HISTORIC DISTRICT REVIEW BOARD REGULAR MEETING AGENDA

Agenda Item: APPLICATION FOR AN ADDITION, HDRB #25-008, to consider an application for a Certificate of Appropriateness for the addition of a mudroom that will partially enclose an existing porch at the single-family residential building located at 631 Nash Street, Herndon, Virginia.

Subject: APPLICATION FOR AN ADDITION, HDRB #25-008, to consider an application for a Certificate of Appropriateness for the addition of a mudroom that will partially enclose an existing porch at the single-family residential building located at 631 Nash Street, Herndon, Virginia.

SHEET NUMBER: **A1.1**

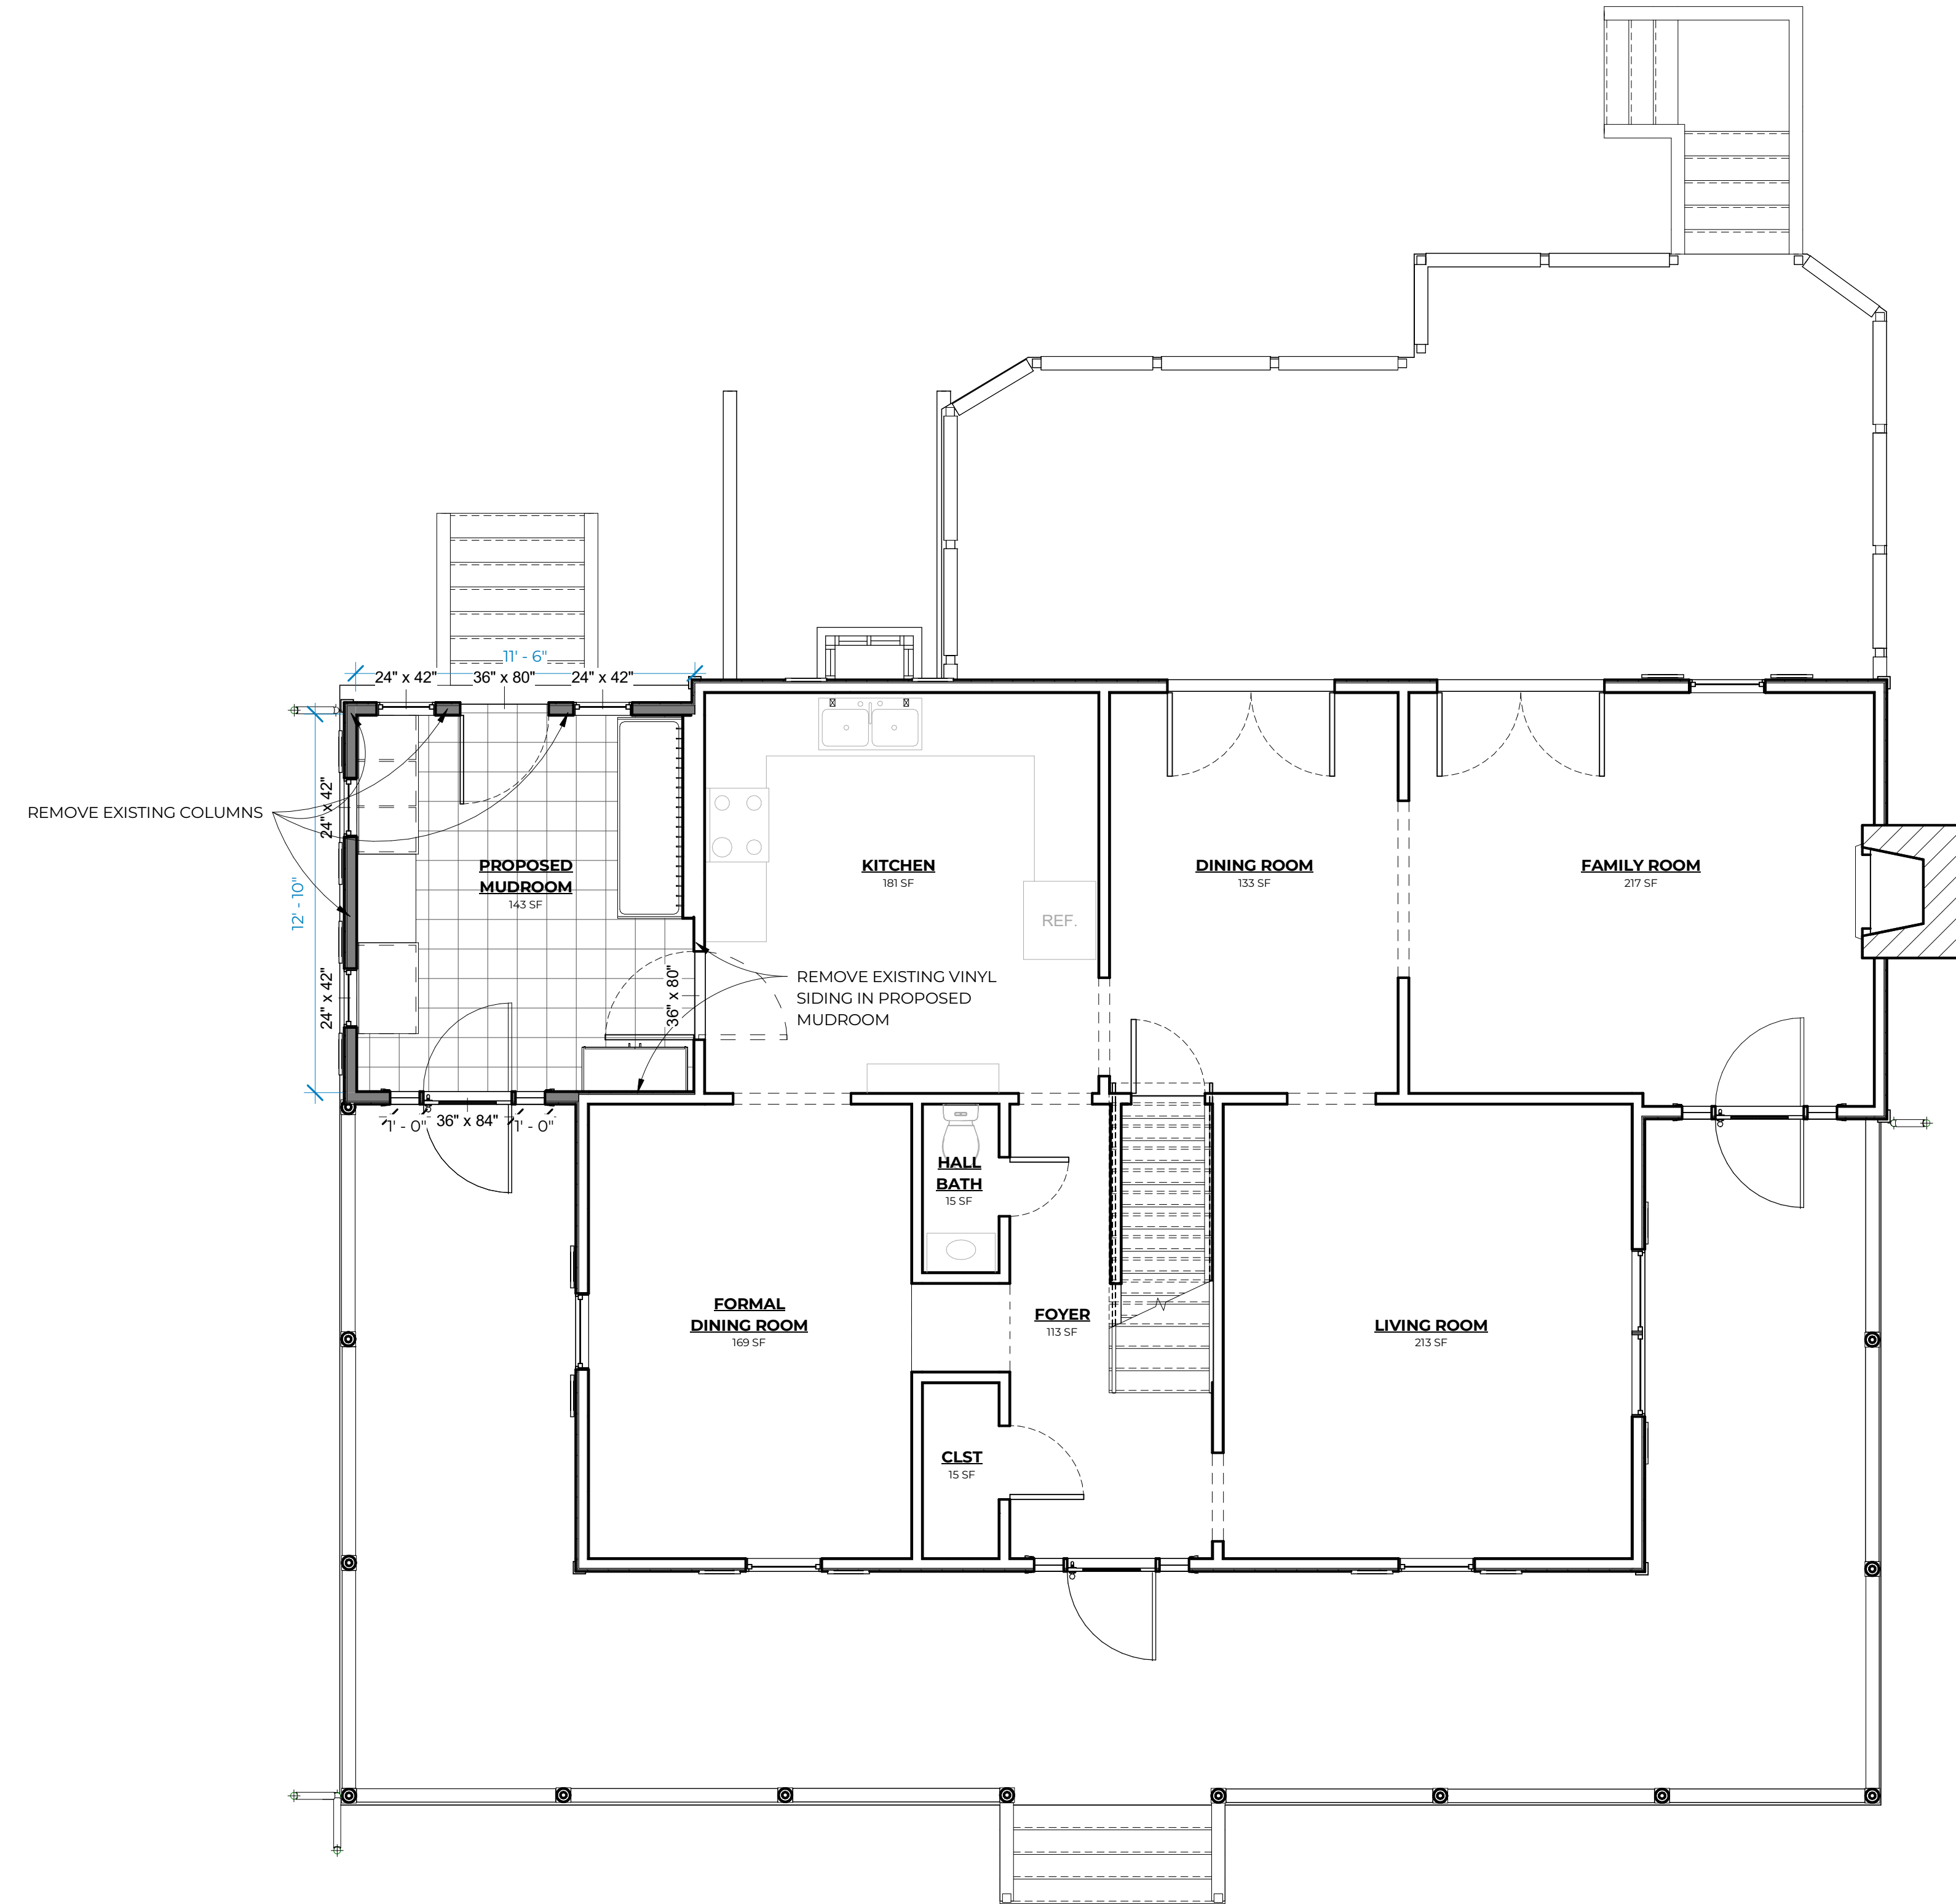
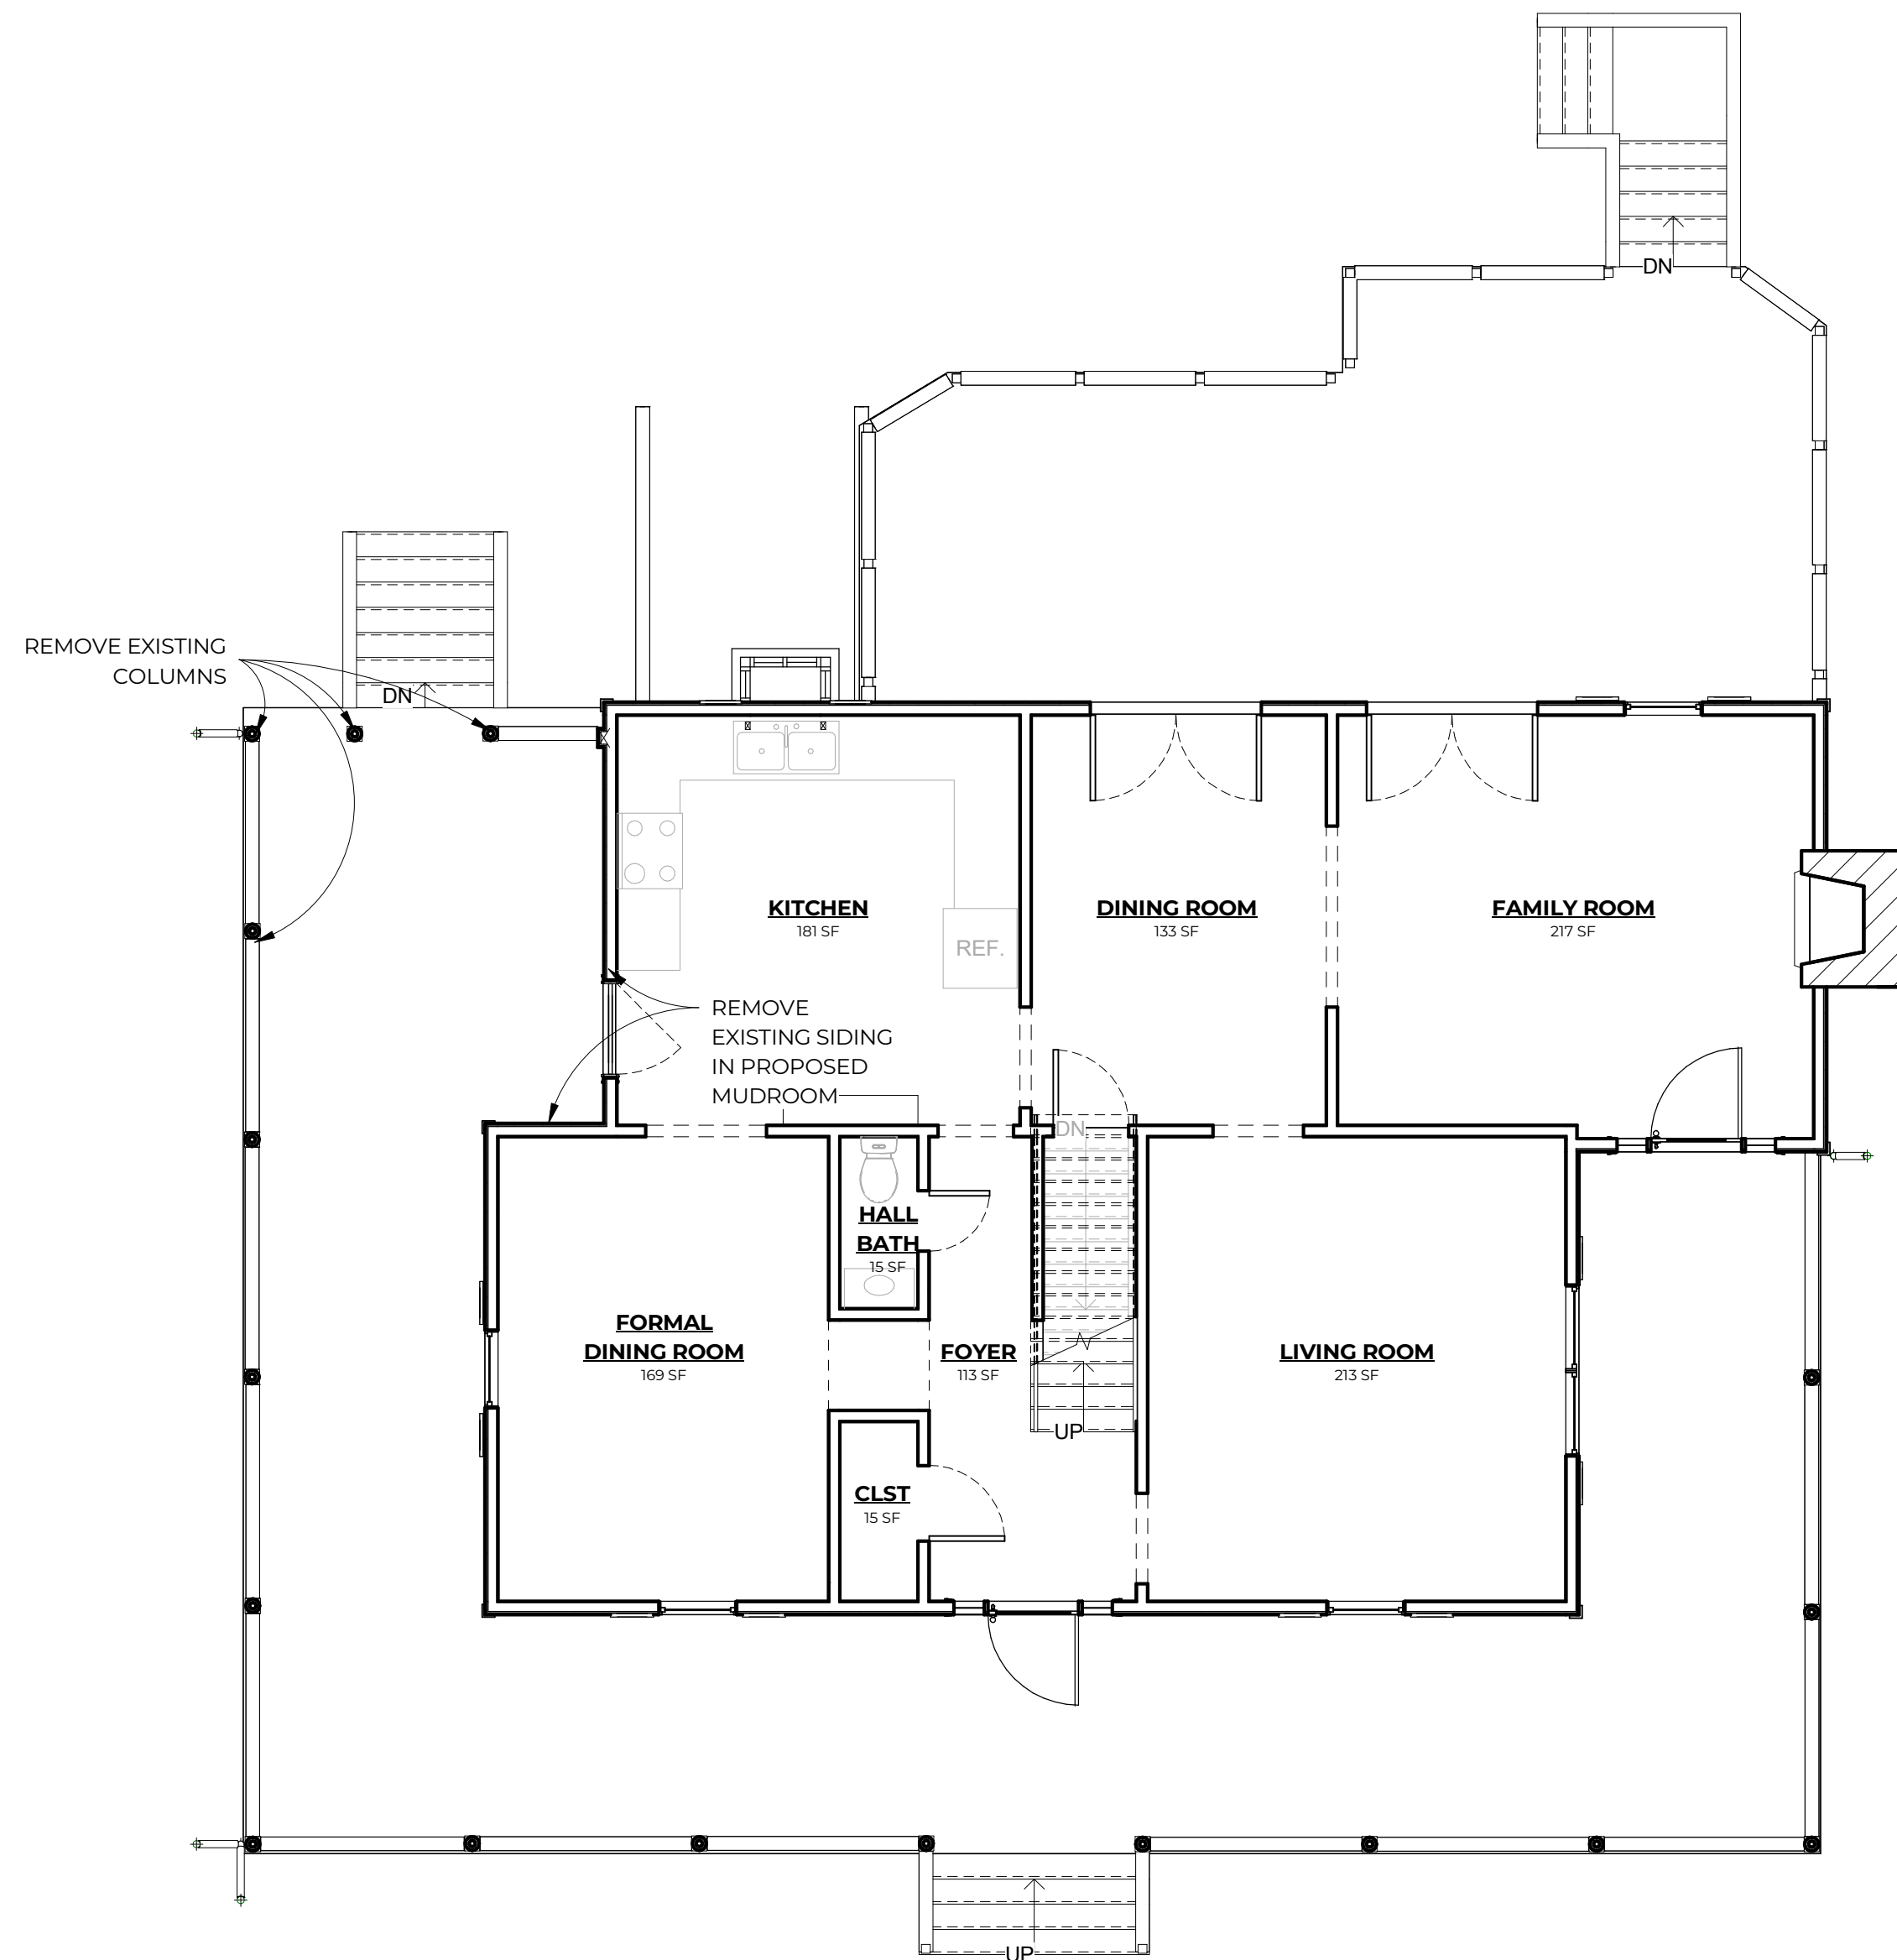
- Clarification is needed from the applicant on what will be demolished and/or removed as part of the scope of work. This can be a written narrative and/or a drawing demonstrating the elements proposed for removal.

- A plan demonstrating existing and proposed conditions that clearly illustrates how the new enclosure will interact with the existing wall plane and door on the east elevation, as well as the proposed material loss at the connection point to the building.

- The revised drawings include an existing and proposed floor plan that demonstrates that four porch columns and associated railings will be removed from the exterior of the porch (A1.1). The drawing also shows that the vinyl siding on two exterior walls of the dwelling will be removed. These walls and a doorway will be converted to interior features as part of this modification. The door of the converted doorway will be reused as the exterior door of the addition.
- Detail 3 on sheet A2.1 shows that the storage entry door will be custom made, with 2x framing, faced with plywood and lattice to match the exterior.
